Accessible Parking Engagement Summary

January 2021

Consistent with directions in the Accessibility Framework, the City is developing Accessible Parking Development Regulations that identify the required accessible parking associated with private land development and city-supplied parking (on-street, parkades, and surface lots).

Plan 1.A - Is my recommended plan that includes all types of accessible vehicles. This plan serves all people.

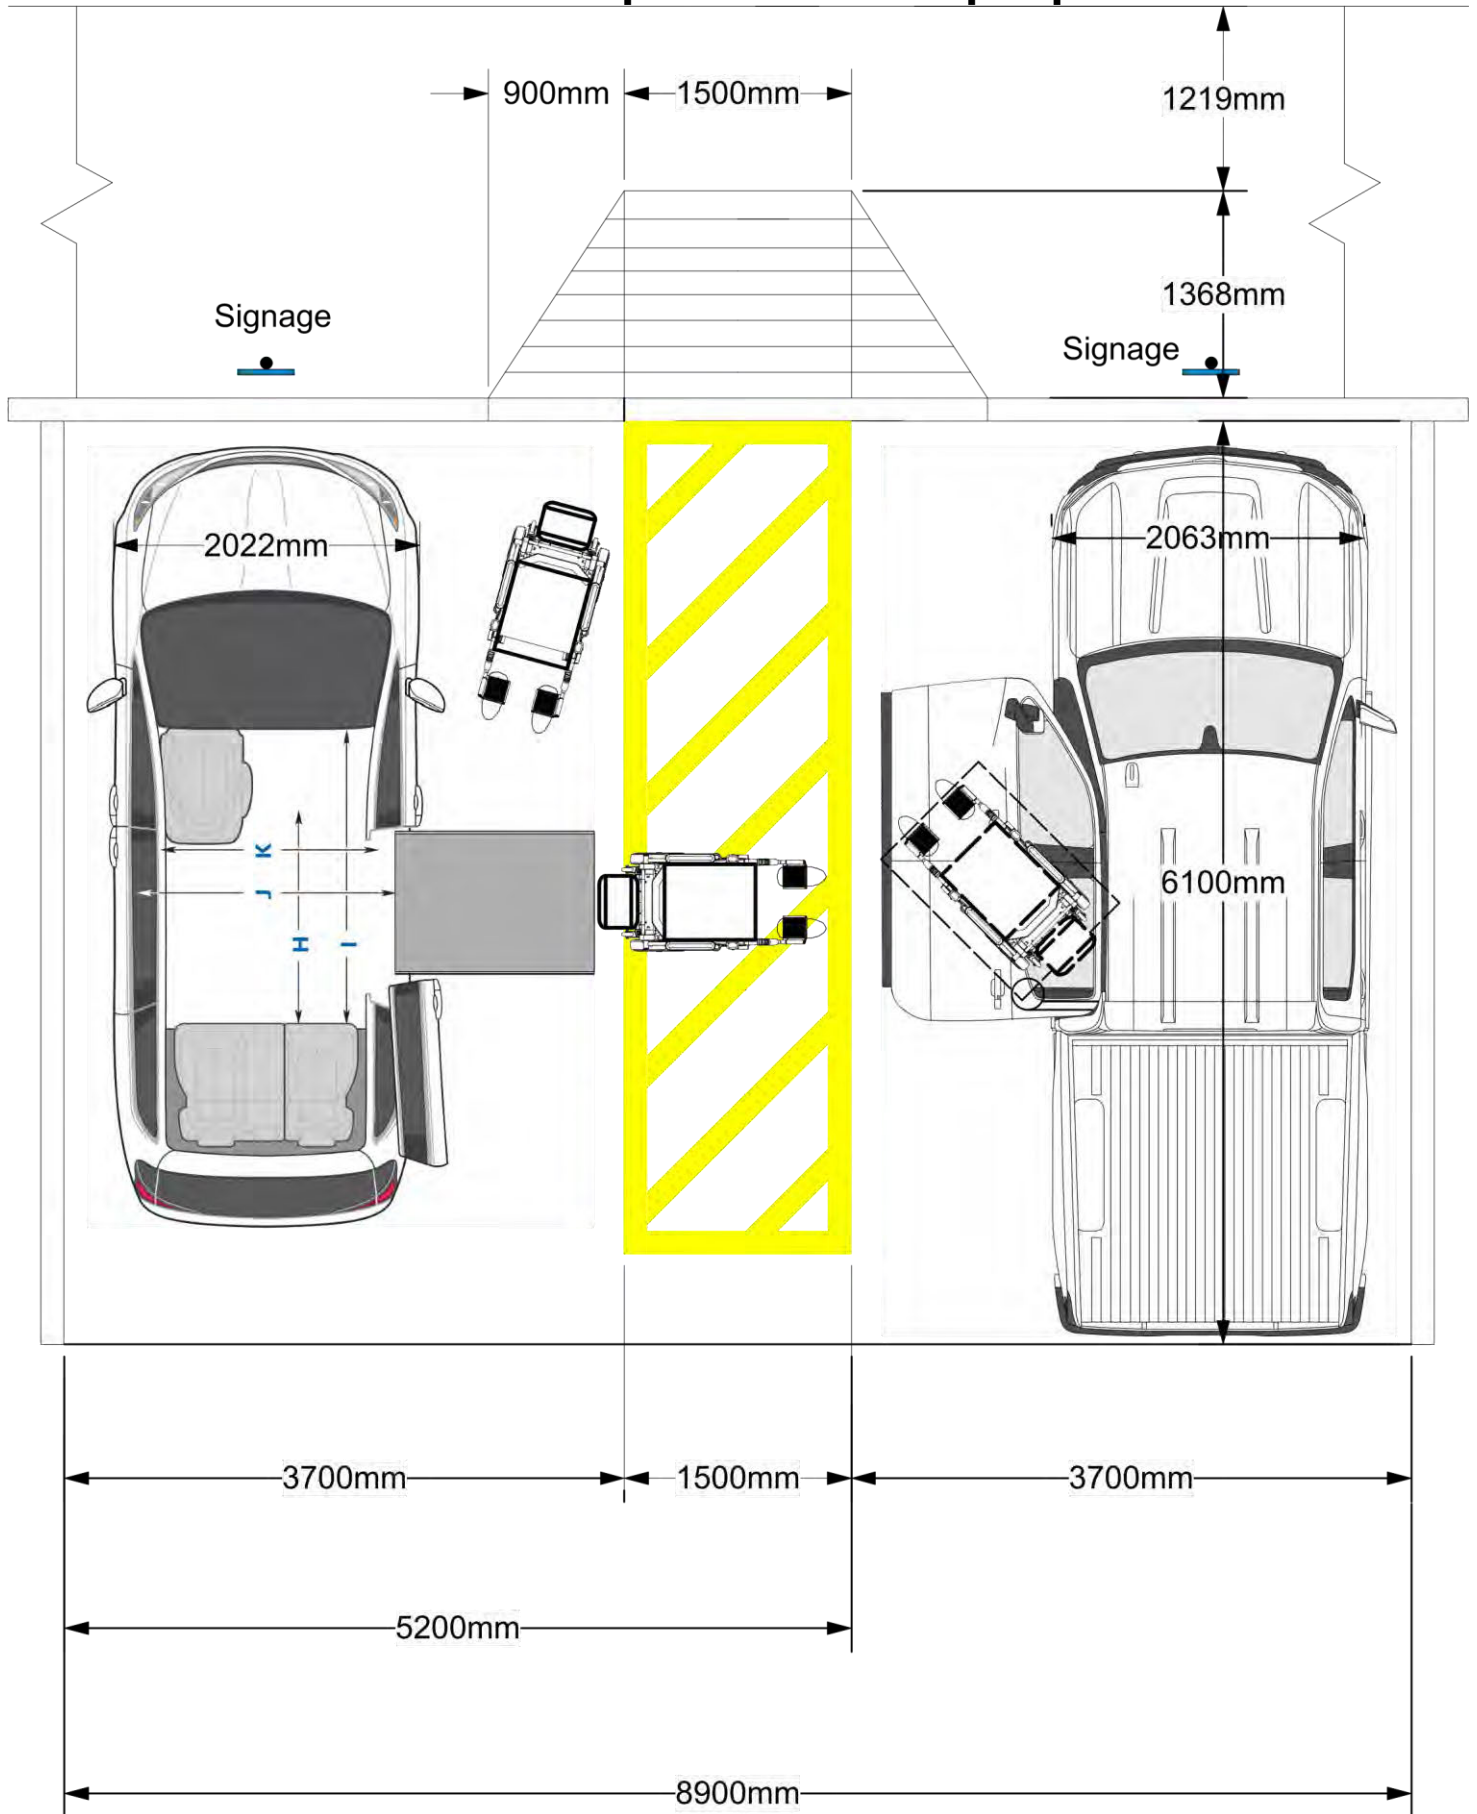
This plan accommodates all vehicles including: Right side loading Vans, Left side loading Trucks, SUVs and Cars. I just met a guy here in Victoria at PISE who has a left side loading Truck. He told me that many accessible parking stalls are too small and the stalls that are big enough he must back into. Do you like backing up your large vehicle into a stall. Current parking stall widths are not wide enough for Right side loading Vans either. Often, I must park in the back of the parking lot. And when you are less than 4ft tall navigating a parking lot is quite dangerous.

Accessible parking stalls need to be bigger, which is an unfortunate fact. Municipalities want a retrofit plan; a plan that can be easily changed back. A plan that would NOT require the scraping and repainting of extra parking lines. They want to shove people into a hole that is not quite big enough and are not safe.

Drawing 1.A: This drawing shows how much room is actually needed to serve all people with varying vehicle types in a safe manner.

Plan 1.B-1 - Is NOT recommended. This plan does not account for all accessible vehicles types.

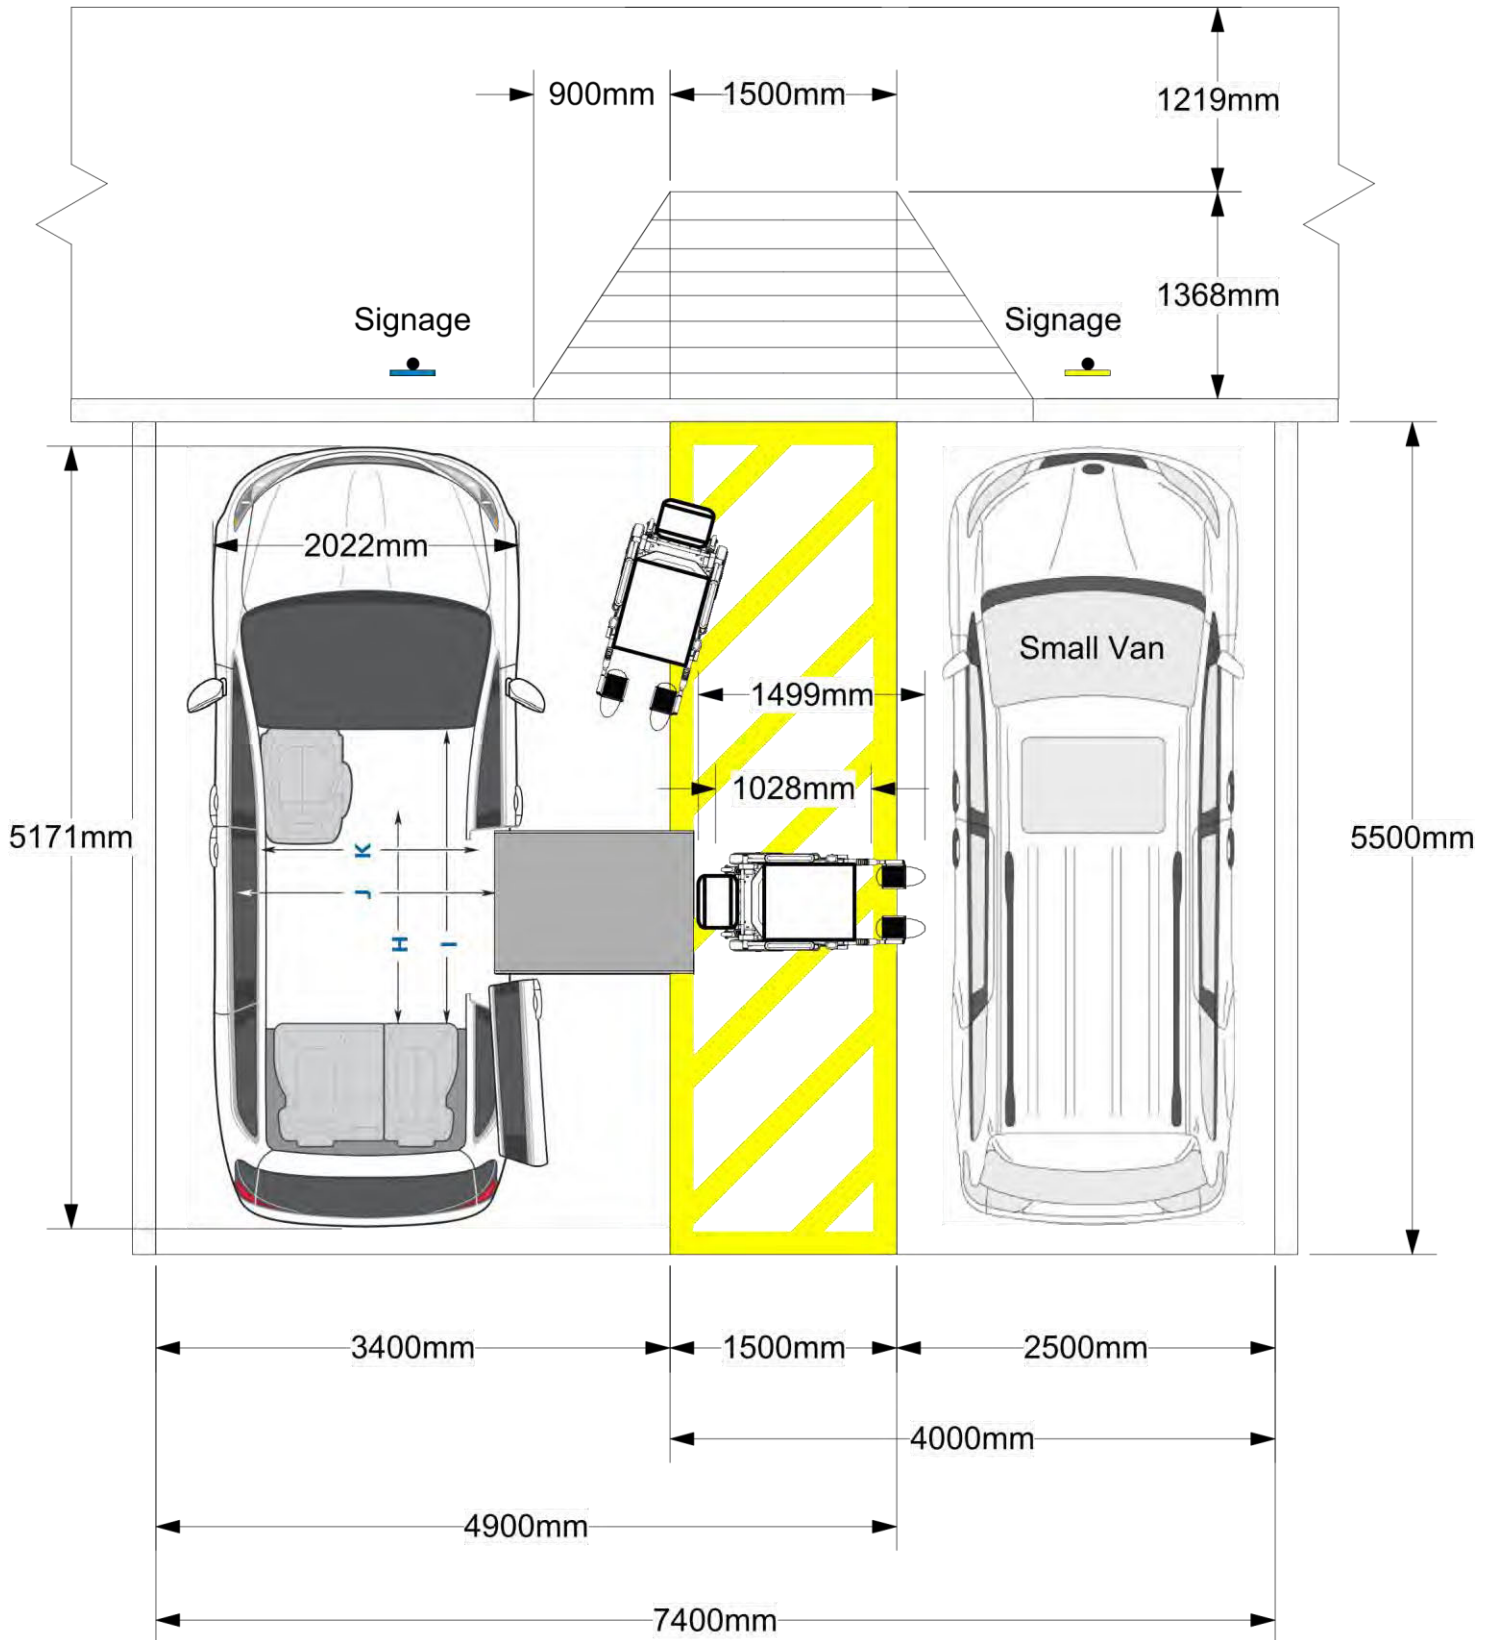
Plans 1.B-1 through 1.B-3 are NOT Recommended: The current approved plans are not safe and do not serve all vehicle types. The plan does not have sidewalk dimensions? Often the side walks are not wide enough and many parking stalls do not have the wheel stoppers.

- Having only a few inches between your toes and the next vehicle is a bad idea.
 - o People with cerebral palsy have and uncontrollable reflex response; if someone honks or make a loud noise they will jump which can cause them to uncontrollably drive their chair into the side of a parked car.

- o People with neuromuscular disabilities like me are very weak and if I run over a small rock while disembarking this can cause my arm or hand to move forward. My hand falls onto the joystick and I can not stop until a caregiver takes my hand off the joystick.

- No mention of sidewalk dimensions? Many side walks that run along buildings are not wide enough to accommodate a properly built ramp. Some are too steep and pose a tipping risk. If stalls have no parking stops big trucks bumpers over hang the side walks. And It is a waste of money to build these ramp cut outs to know where. Yes, these ramps do exist.

Plan 1.B-2 - Is NOT recommended. This plan does not account for all accessible vehicles types.

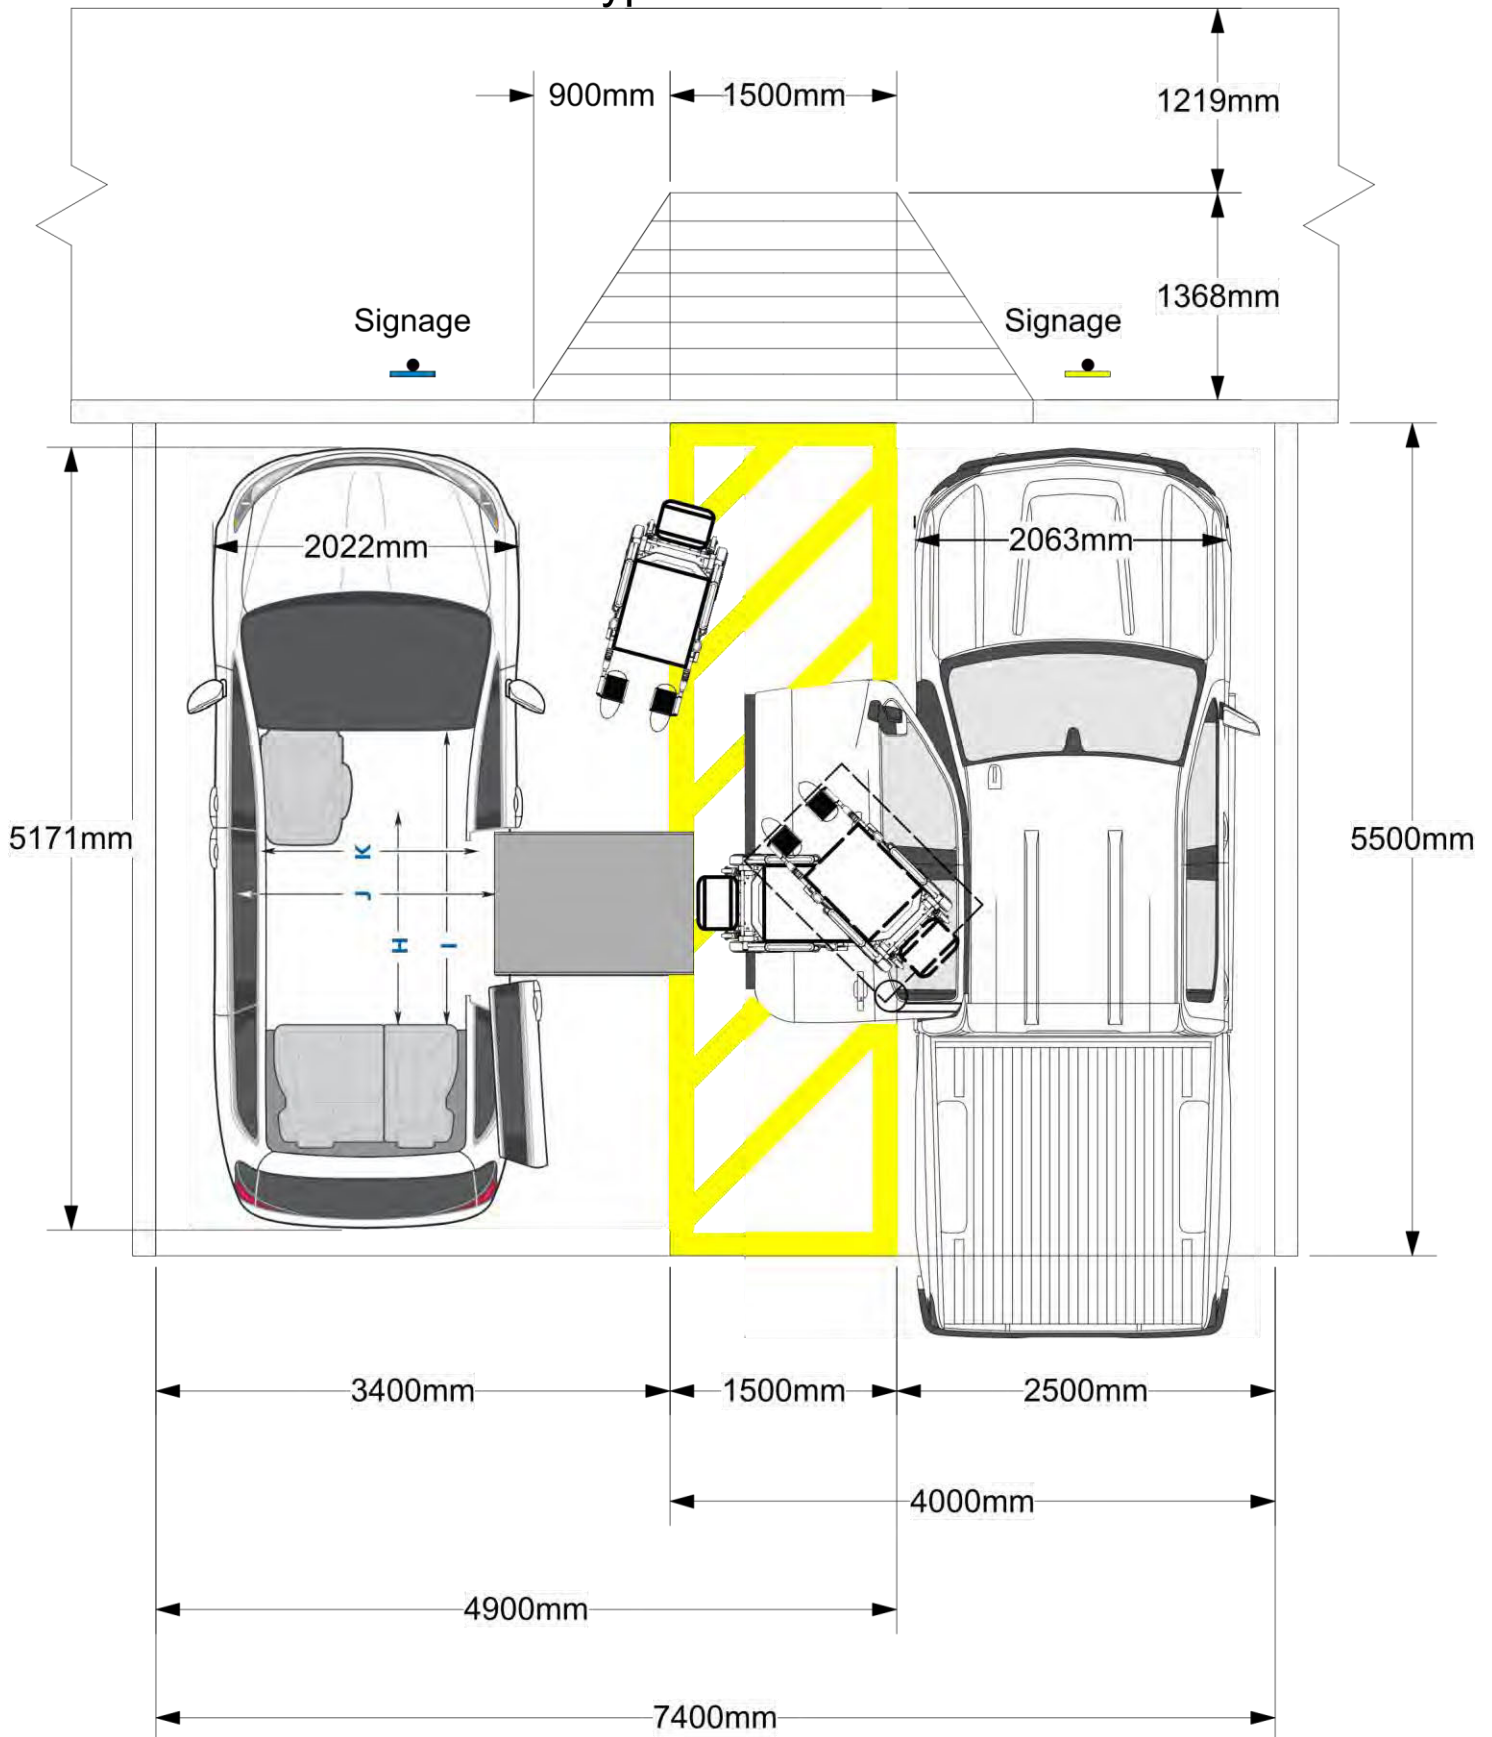
Page 3: **Plan 1.B-1 - Is NOT recommended.** This plan does not account for all accessible vehicles types.

Exhibit 3 - More effective Accessible Parking Signage, with enforcement messaging

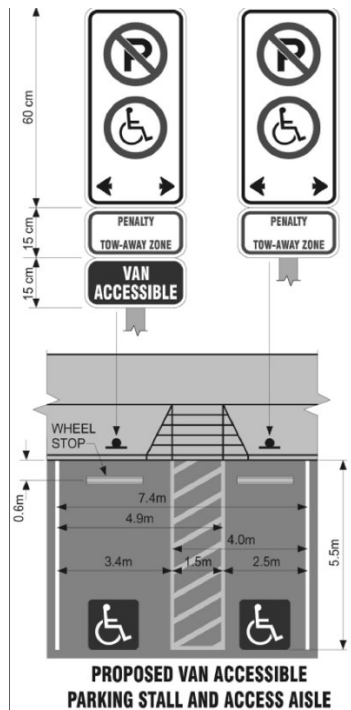
In most underground parking, stalls will be against a wall and curbs will not be visible. Other wall markings may be advisable. Two circumstances – pole and wall signage should be covered. How are they to be mounted to concrete walls, or is other forms of signage or markings allowed in this circumstance? How about a blue stripe at a certain level? Can signage be affixed with glues that do not allow them to be pried off any more easily than removed from a post?

This would be improved by enforcement messages and, particular to private parking, the phone number of the owner to whom infractions should be reported. Neither police nor Bylaw officers will enforce infractions on private parking unless it is the owner who will respond. This is a large gap in the regulatory regime that essentially makes AP restrictions on private property a fiction. The need to contact someone who can request enforcement is essential to the success of AP in the private sector. See Exhibit 3 below. It indicates penalties, but should have phone numbers too.

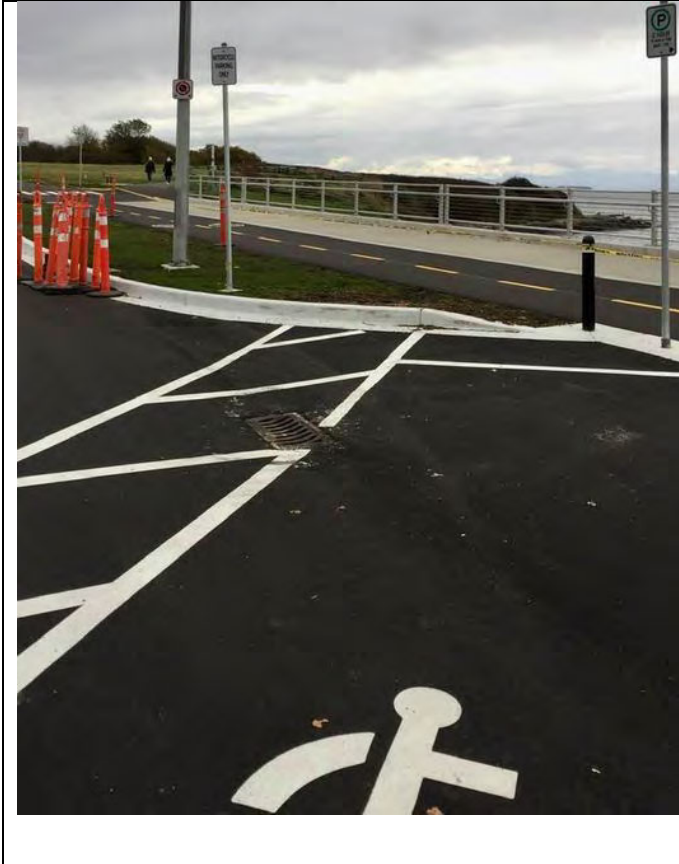
“discourages” should be “Prevents any uncertainty” and there should be more to reinforce this principle, including requiring signage on each stall, rather than as at the Breakwater where bookend signage is used (I think), and signage inserted elsewhere that indicates Penalty – Tow-Away.

Why are these less specific than the private requirements?

Guideline should address position of the wheelchair icon within the stall – centred but toward the rear?
